## Product Change Notice

Part Number : E-2704-1      Date: 20231106

#### 4. Pictures of Original Damper Ring & New Damper Ring for E-2704-1

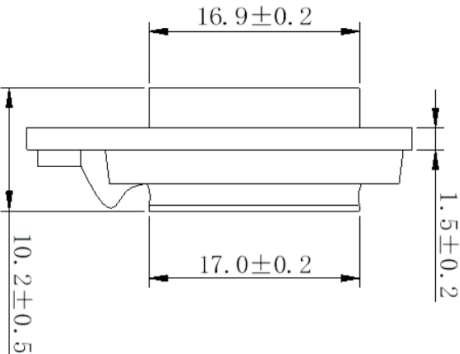
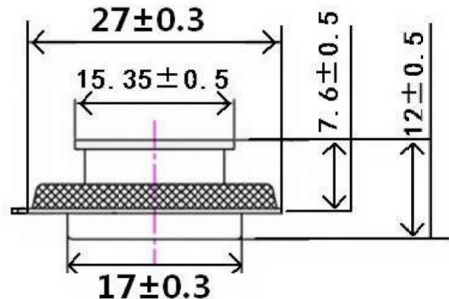
Change Type	<input checked="" type="checkbox"/> Material / Specification Change <input type="checkbox"/> Equipment Change <input type="checkbox"/> Process Change <input type="checkbox"/> Man Change				
Product Type	Exciter	Model No.	E-2704-1	Affected Date of the Change	2023.11.06
<b>Part Changed :</b> Inner damper ring					
<b>Reason for Change :</b> Damper ring raw material has been discontinued and has been replaced with new material.					
<b>Area to be Changed</b>					
<b>Before Change :</b> 1. Specification Diagram			<b>After Change :</b> 1. Specification Diagram

Original E-2704-1    New E-2704-1			New E-2704-1		
2. Inner diameter of ring: $16.9 \pm 0.2 \text{ mm}$ 3. Height of ring $10.2 \pm 0.5 \text{ mm}$			2. Inner diameter of ring: $15.35 \pm 0.5 \text{ mm}$ 3. Height of ring $12 \pm 0.5 \text{ mm}$

Except for a smaller diameter of the damper ring, there are no other changes. It will not cause impact on the use, function, and performance.
